RE: FW: Pizza Hut revision

Subject: BAR Action - 1001 West Main Street - Nov 15, 2016

BAR 16-11-03 1001 West Main Street Tax Parcel 100050000 Mark Green, E-Corp, Owner/Kevin Schafer, Design Develop, Applicant Exterior Changes

# CITY OF CHARLOTTESVILLE BOARD OF ARCHITECTURAL REVIEW STAFF REPORT November 15, 2016

EXTERIOR PERSPECTIVE

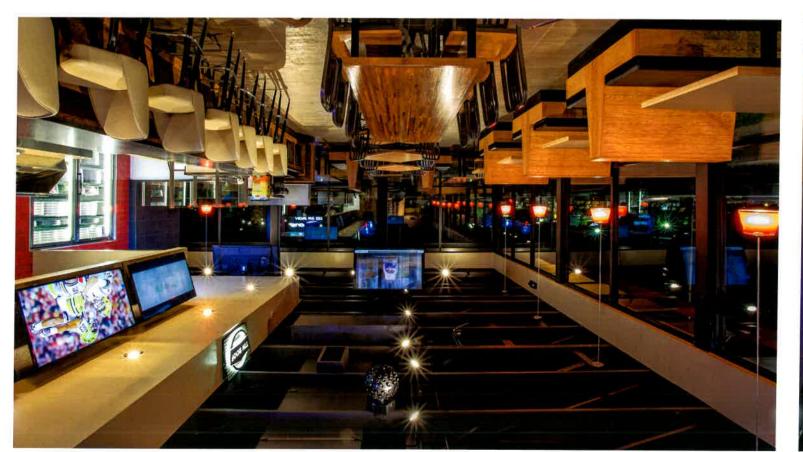
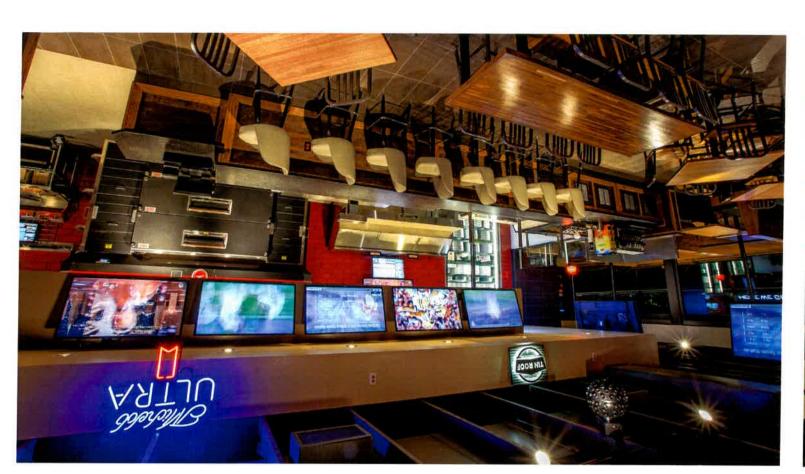
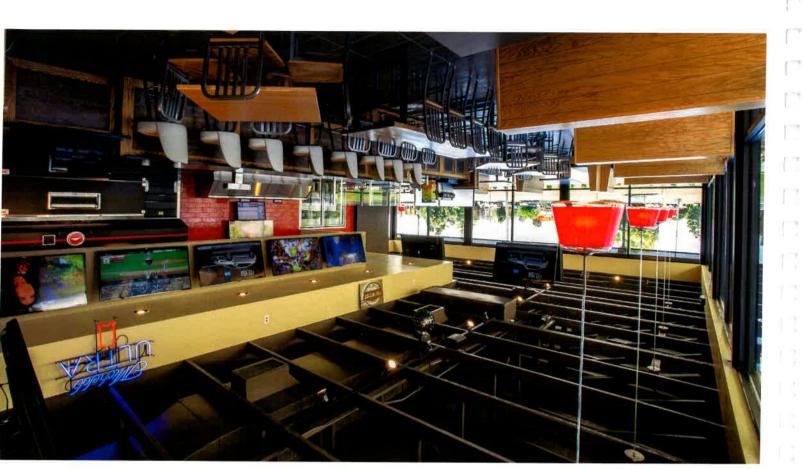
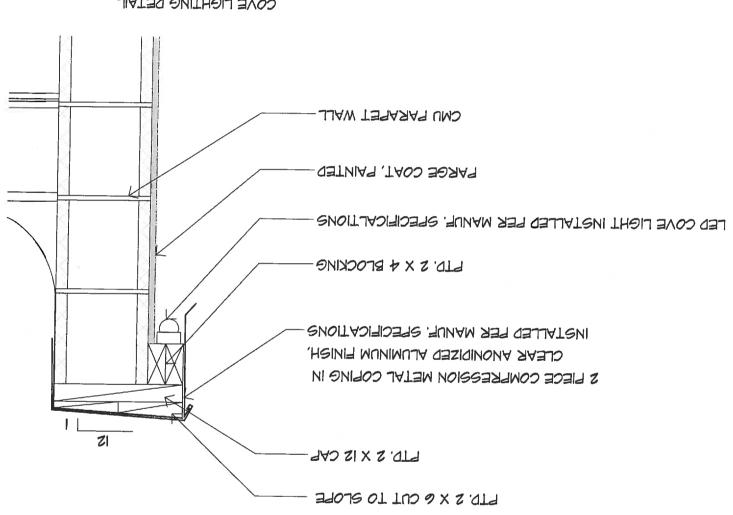
In the renderings the canopy fascia is shown as a charcoal grey - not the powder coated white shown in the detail pdf?

a: The canopies were previously submitted in white. To match the color tones of the new building, we changed to the charcoal to match the painted header bands, as the stark white seemed to contrast a bit too much from the rest of the building. These drawings were from the previous permit set and had not yet been updated with a call out for the new color.
